AMENDMENT OF SOLICITATION / MODIFICATION OF CONTRACT			1. Contract Number	Page of Pages 1 12	
2. Amendment/Modification Number DCAM-2007-B-0004-009	3. Effective Date August 21, 2007	4. Requisition/Purchase Request No.	5. Solicitation Caption Renovation of Inmate Showers at the D.C. Jail

SOLICITATION: DCAM-2007-B-0004 RESPONSE TO OFFERORS QUESTIONS

ACCESS PANEL DETAIL

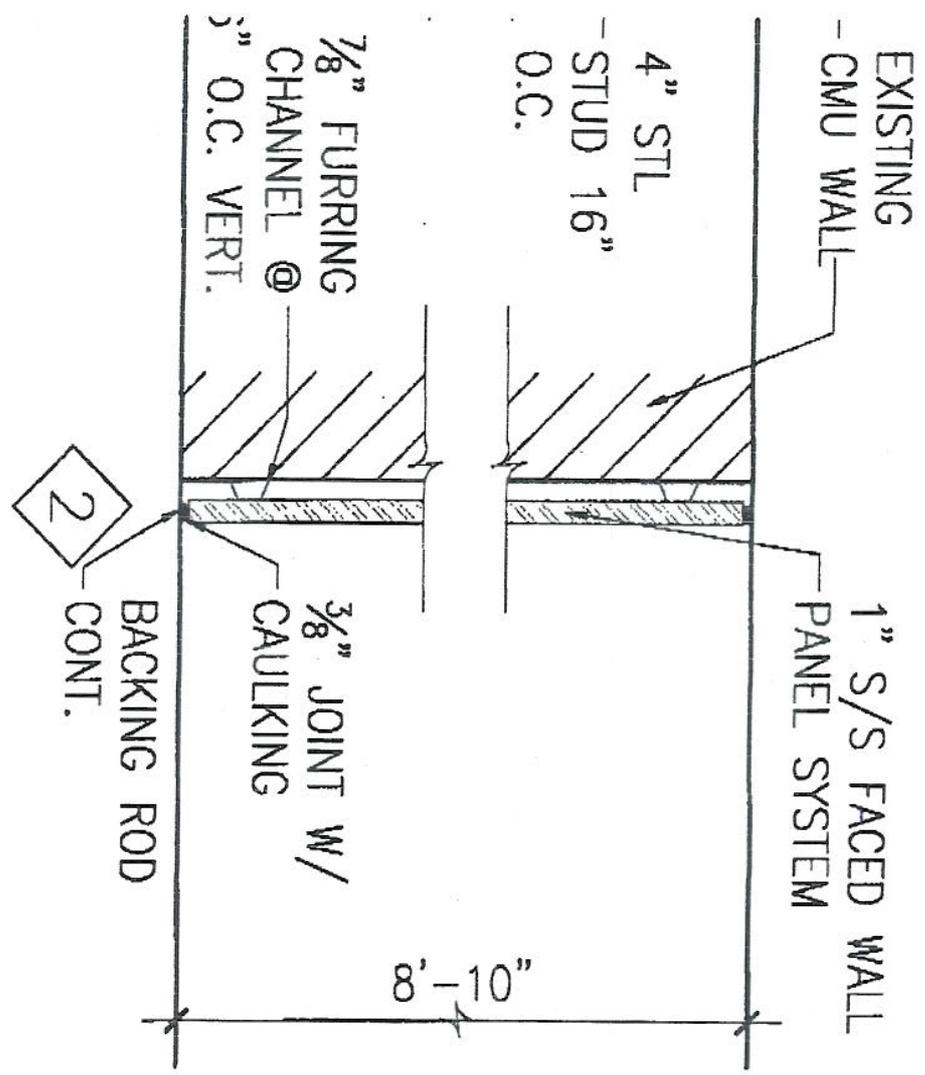
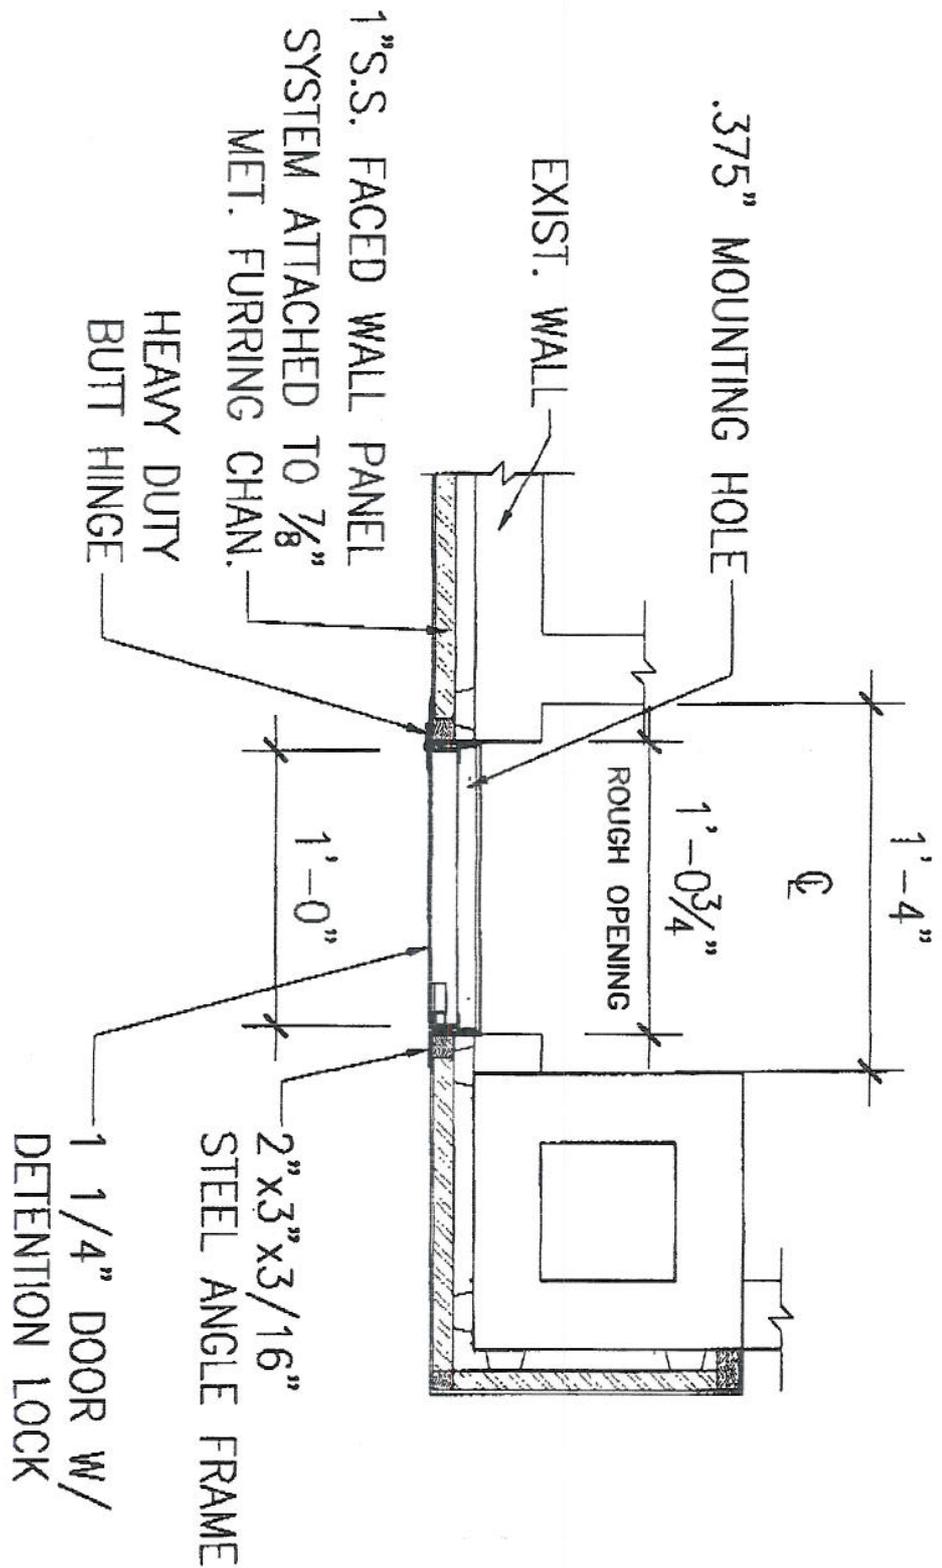
Question	Response
9	<p>There are no specifications...or locations shown...for ceiling access panels. Are ceiling access panels required? If, so please provide specific information such as the number required, location, dimensions, specifications, manufacturer information and product data.</p>	<p>There are no ceiling access panels.</p>
10	<p>The contract drawings do not address the disposition of the existing mop sink room doors or the existing chase wall doors. Please address.</p>	<p>The existing mop room sink door shall be replaced with a new Door # 103, See Door Schedule on Drawing A-14. Door Hardware shall be stainless steel lockset 161R w/(3) silencers, 1-1/2 butts, hinge base metal S.S. pins and non removable of pin when door is in closed position for out swing door.</p>
11	<p>What is the construction of the existing utility chase walls?</p>	<p>Masonry</p>
12	<p>How is the contractor to access the existing utility chases in order to access and rework exiting plumbing piping?</p>	<p>Access will be by keys</p>
